**RAI Volume 2, Chapter 2.1.1.4, Eighth Set, Number 4:**

**RAI Volume 2, Chapter 2.1.1.4, Eighth Set, Number 8:**

RAI: 2.2.1.1.4-8-008

Figure 1. Aging Pad 17P Partial Plan and Section Showing Cut Slopes, Northeast Corner

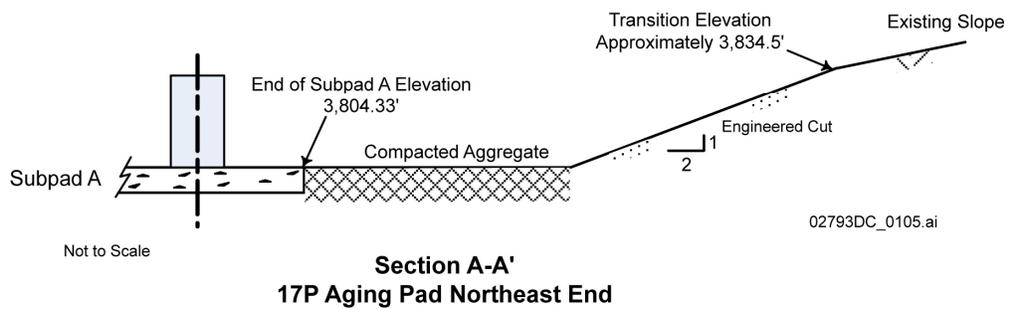
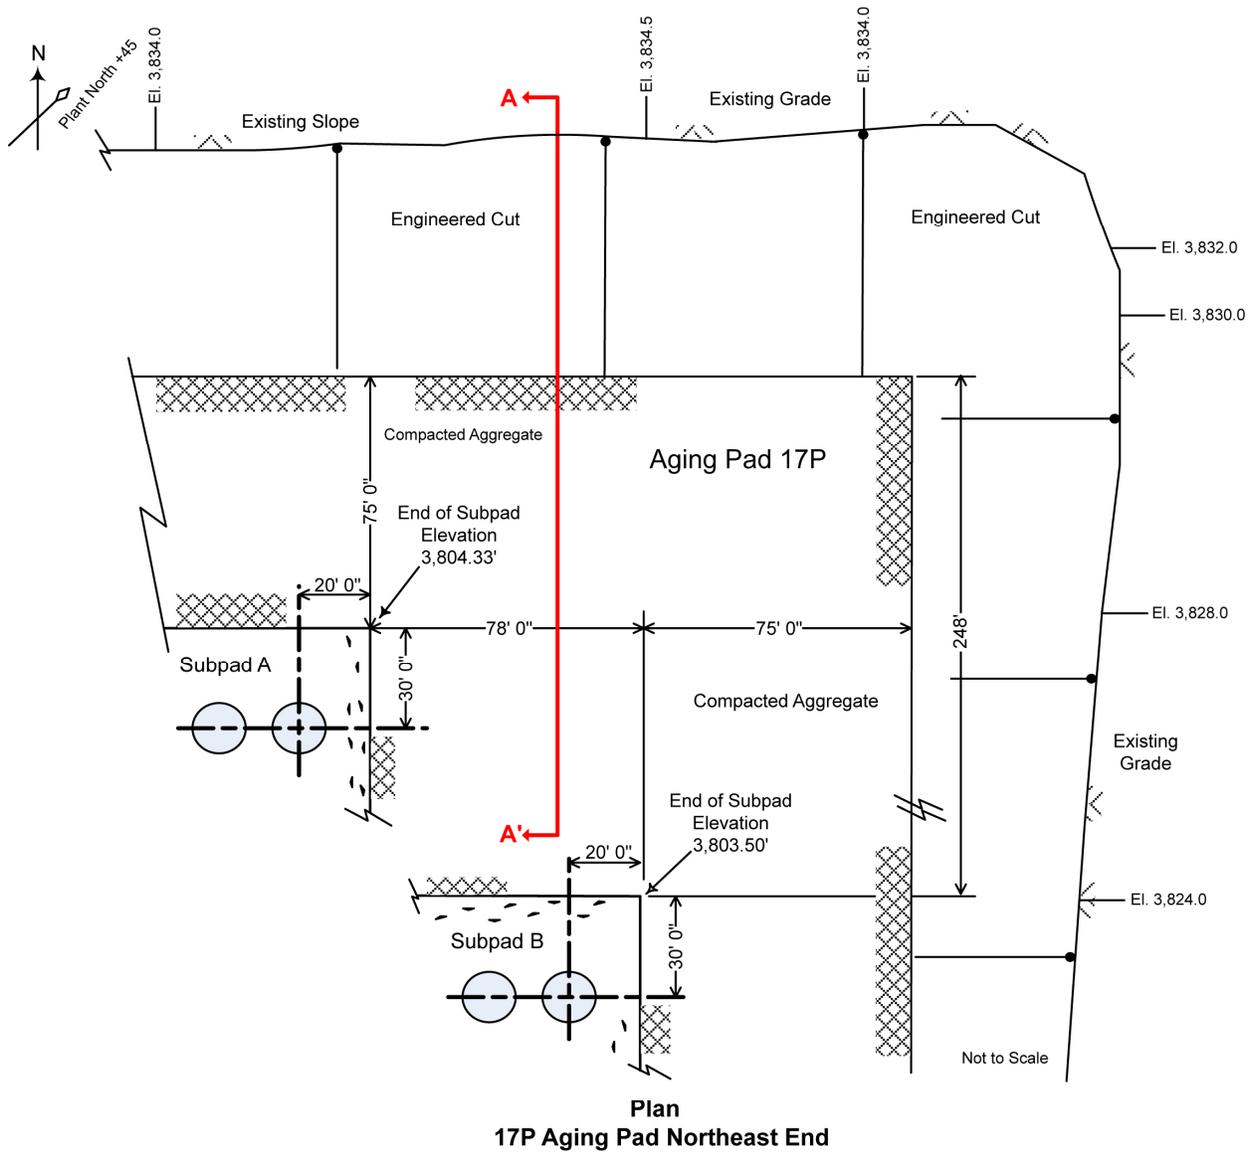
SAR Figure 1.1-129 and information on the terraced layout of the aging pads in DOE's response to a previous RAI (RAI: 2.2.1.1.7-3-001) on this subject suggests that excavation and fill for aging pad foundations could expose the alluvium in cut and fill slopes of up to approximately 9 to 10 m [29 to 32 ft] high. Failure of the cut slope could result in the failed material depositing on the Aging Facility located in the vicinity of the toe of the slope. This material could block the vents of the Aging casks and potentially impact the Aging cask complying with the thermal limit requirement for the fuel being aged at the facility. Failure of a fill slope, where the Aging facility is located on top of the slope, has the potential for the Aging Casks to be in the failure zone and be unstable. Also, transportation routes that link the aging pads to other surface-facility structures (SAR figure 1.2.7-2) could involve cut or fill slopes. DOE has not provided an assessment of the stability of the slopes for static and applicable seismic loading conditions and did not identify potential event sequences resulting from failure of the slopes. This information is needed to determine compliance with 10 CFR 63.21(c)(5) and 63.112(b).

The compacted aggregate aging pad periphery typically extends 75 ft. beyond the concrete mat, such that vertical aging cask would be no closer than 89 ft to the upslope hillside from the toe of the engineered cut that will be no steeper than 2H:1V. As shown in Figure 1, a slope failure of an engineered slope 29 to 32 ft high would not result in soil sliding onto the aging pads and contacting an aging cask. The distance of the aging pads and vertical aging casks from up-slope hillsides precludes soil from sliding onto the concrete aging pads and contacting the aging casks (BSC 2007a, p. A-4). The layouts for aging pads 17P and 17R also illustrate that the engineered design recognizes and mitigates the potential failure of cut and fill slopes. The highest engineered slope (approximately 32 ft) is located in the northeast corner of aging pad 17P (BSC 2008a and Figures 1 and 2).

Because of the offset of the toe of the engineered cut slopes from the first row of vertical aging casks, it is improbable that failure of even the highest elevation slopes would result in undercut of the concrete of the aging pads sufficient to cause a structural failure of the pad and sufficient pad displacement to cause tipover of any aging casks. Notwithstanding the improbable nature of pad displacement due to slope failure, those vertical aging casks that are located in the outer row of the aging pads adjacent to a fill slope are included in the model. Based on *Geologic Repository Operations Area Aging Pad Site Plan* (BSC 2008a) and SAR Figures 1.2.7-3 and 1.2.7-4, the number of vertical aging casks in the outer row of the fully loaded aging pads adjacent to a fill slope would be 76. The exceedance frequency of the DBGM-2 earthquake is

Figure 3. 3D Layout of Aging Pad Sites Showing Surrounding Roadways

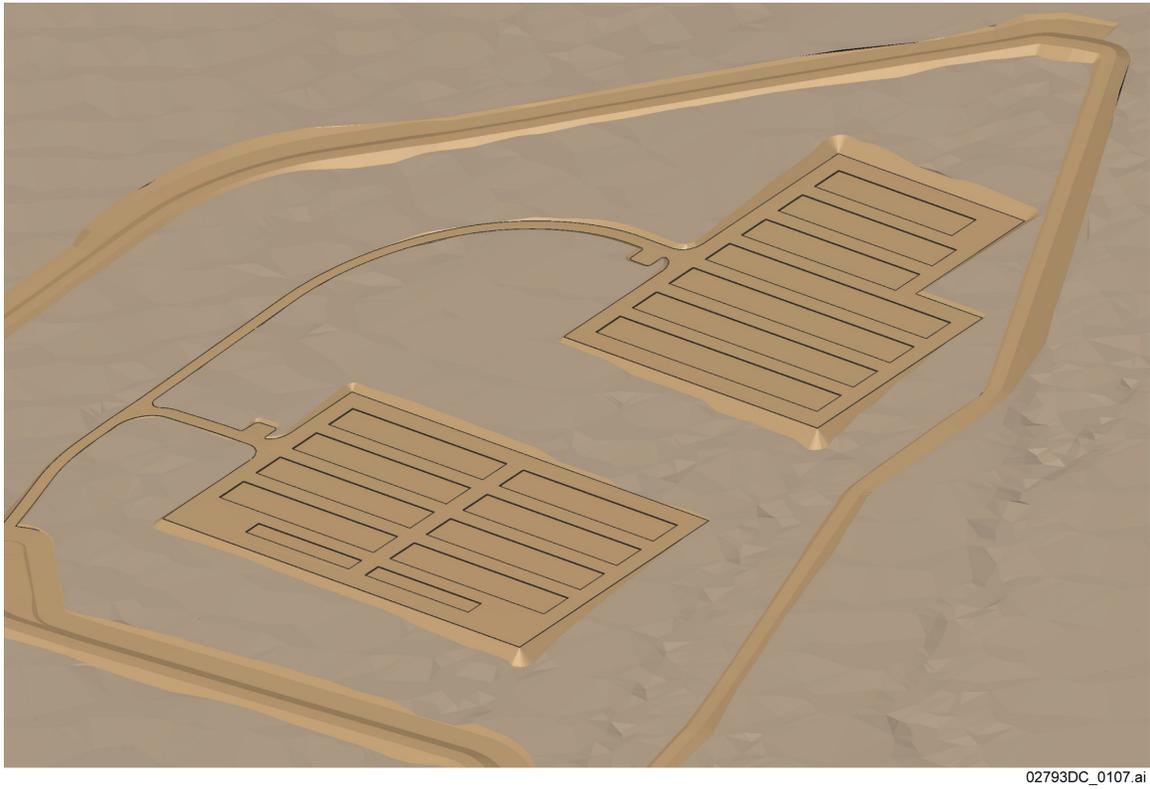
Provide an analysis of potential event sequences related to failure of cut or fill slopes near the aging pads or on transportation routes to and from the aging pads, or explain how these event sequences will be prevented or mitigated.

The *Geologic Repository Operations Area Aging Pad Site Plan* (BSC 2008a) shows the general layout of the aging pads, the relative proximity of the aging pads to the various surface facilities of the repository, security fencing surrounding the aging facility, access roads, and the designation for each of the two aging pads (17P and 17R). The aging pad site plan also provides the topography and preliminary cut and fill information for the aging facility slopes. Further perspective on the topography and preliminary cut and fill information are shown on Figures 1, 2, and 3.
